Subject: A202302140-01 - Service Update  
Engine Oil Pressure Sensor Performance Error  
Revised Part, Warranty and Service Procedure sections

Models: 2020 Buick Encore GX  
2021 Chevrolet Trailblazer  
Equipped with 1.2L Turbo Engine (RPO LIH)

## A202302140 Engine Oil Pressure Sensor Performance Error

**Revision Description:** This bulletin has been revised to update the service procedure, add part information, and update the warranty information section, including adding floor plan reimbursement. Please discard all copies of A202302140.

5584378

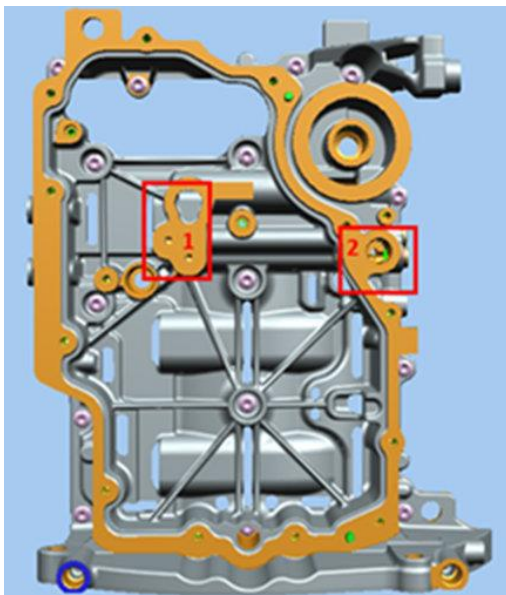
4. Raise the engine speed to 2,000 rpm for 30 seconds.
5. Rev up the engine rpm to 4,000 rpm limit and hold for 15 seconds.
6. Release the acceleration pedal to go down rpm to idle and wait for 15 seconds.

**Important:** One test cycle is from steps 4 to 6.
